## THM 4T65-E 2002-2003 OIL PUMP CHANGES

CHANGE: 1

04-07 Page 1 of 5

Figure 1
AUTOMATIC TRANSMISSION SERVICE GROUP

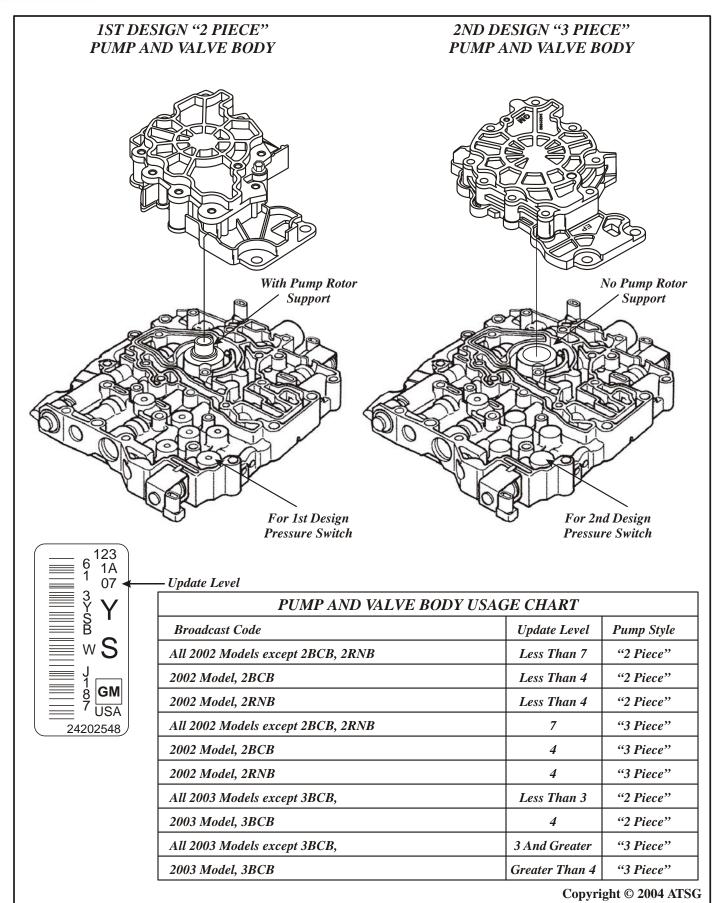
A physical inspection of the I.D. Tag will be *mandatory*, to obtain the update level, before ordering components for these transaxles. Refer to Figure 1 for the location of the update level on the I.D. Tag and a usage chart for design level of pump assembly.

- (2) OIL PUMP ASSEMBLY RETAINING BOLTS Are a different length than the previous design level oil pump bolts.
- (3) VALVE BODY ASSEMBLY The pump rotor support sleeve has been removed from the valve body to accommodate the "3 Piece" design level pump assembly, as shown in Figure 1.

Figure 2

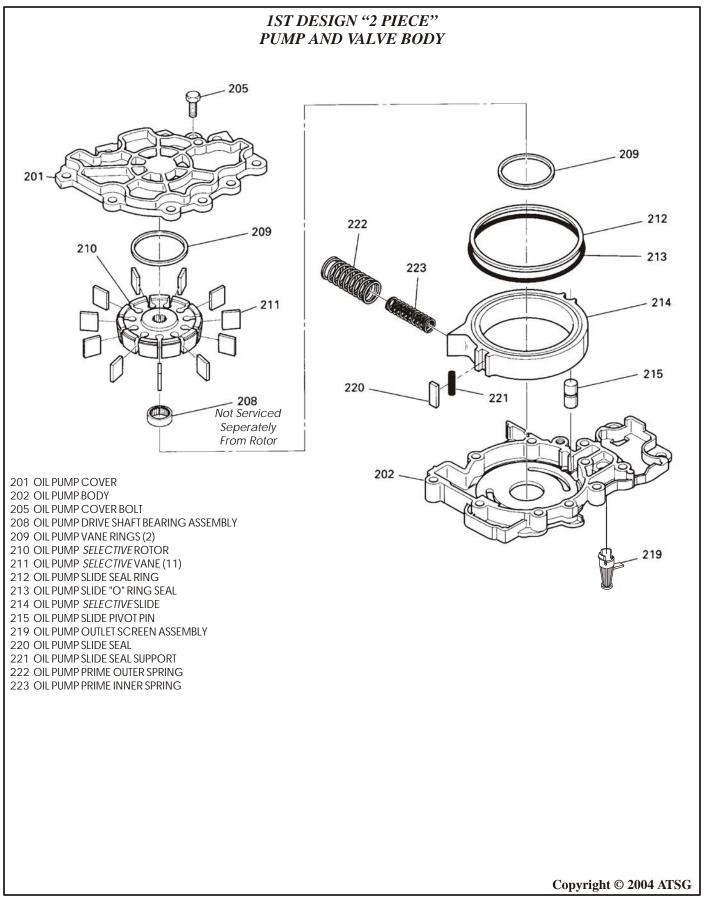
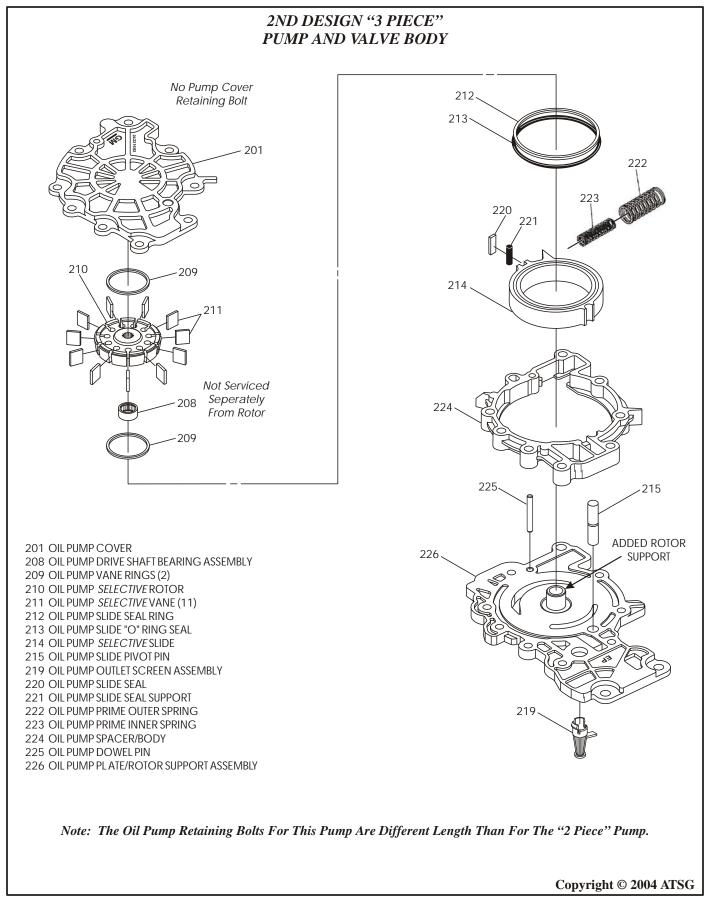
Beginning in June of 2002 Hydra-matic changed the design of the Oil Pump Assembly on 2002 and 2003 models of the 4T65-E transaxles. The "2 Piece" design level pump has been changed to a "3 Piece" design and has affected many of the related parts. The "2 Piece" design level pump is illustrated in Figure 2 and the "3 Piece" design level is illustrated in Figure 3.

- (1) OIL PUMPASSEMBLY Changed to a "3 Piece" design, as shown in Figure 3. The "3 Piece" design now incorporates the rotor support sleeve in the pump instead of the valve body. The previous design "2 Piece design level pump is illustrated in Figure 2.
